RE: ESCR CAG Fall 2023 Inquiries

Thank you for your inquiries following the October 2023 CAG walk-through and announcement of the closure of ball fields 3-5. Many of the questions were answered at prior CAG and CB3 meetings, but the answers are reiterated. Please see DDC responses below.

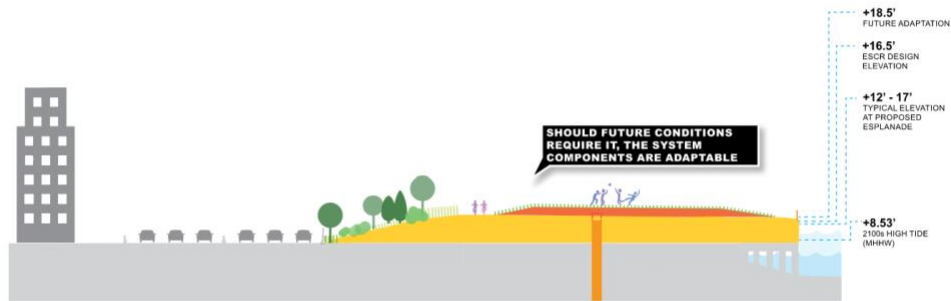
3. Question: Regarding the crossing warnings on the south side of Houston: the first one (most westerly) is about bikes, and it's not clear that the two barriers (off to the side and easy to ignore) are for pedestrians. Indeed, I saw two people crossing the wrong way into the park. This is a real hazard, and it's just too easy to get hit there. Can there be a clearer sign and maybe something graphic since so many park users don't read English?

DDC Response: *The PA1 team has been monitoring this location and making continual improvements to barrier placement and signage. The change has been in effect since May 8, 2023, yet people continue to enter the park from the south side of Houston*

*Street. We added yellow signage in Chinese and Spanish to try and improve compliance with the pedestrian detour.*
